September 20, 2017
P/W 1705-04
Report No. 1705-04-B-4

Subject: Geotechnical Addendum, Response to Cycle Review Comments, LDR-Geology, Regarding Geotechnical/Geologic Feasibility Report for 8247 Paseo Del Ocaso Project, La Jolla Area, City of San Diego, California

Subject: Preliminary Geotechnical Investigation for Proposed Single-Family Residence, 8247 Paseo Del Ocaso Project, La Jolla Area, City of San Diego, California

CROSS-SECTION B-B'
SCALE 1"=10.0' H&V

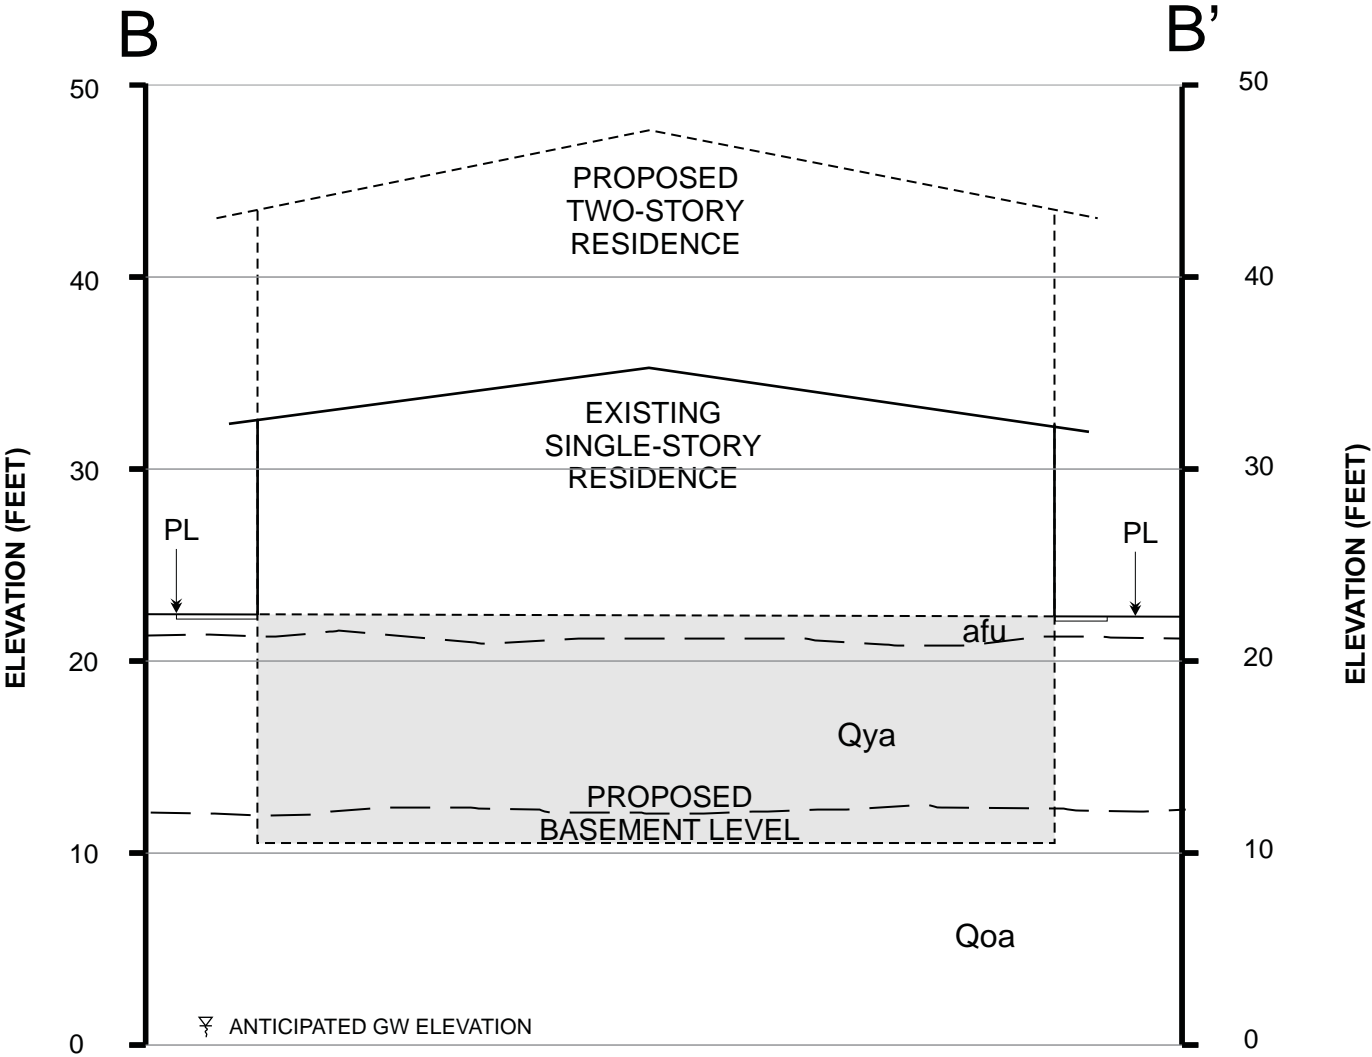
Item 4 -City of San Diego- Provide representative geologic/geotechnical cross sections that show the existing and proposed grades, distribution of fill and geologic units, and groundwater conditions.

AGS response – The attached Preliminary Geotechnical Investigation (AGS 2017b) contains geologic/geotechnical cross sections (AA' & BB') which depict existing and proposed grades, distribution of fill and geologic units, and groundwater conditions. See Plates 2 & 3, Geologic Cross-Sections AA & BB.
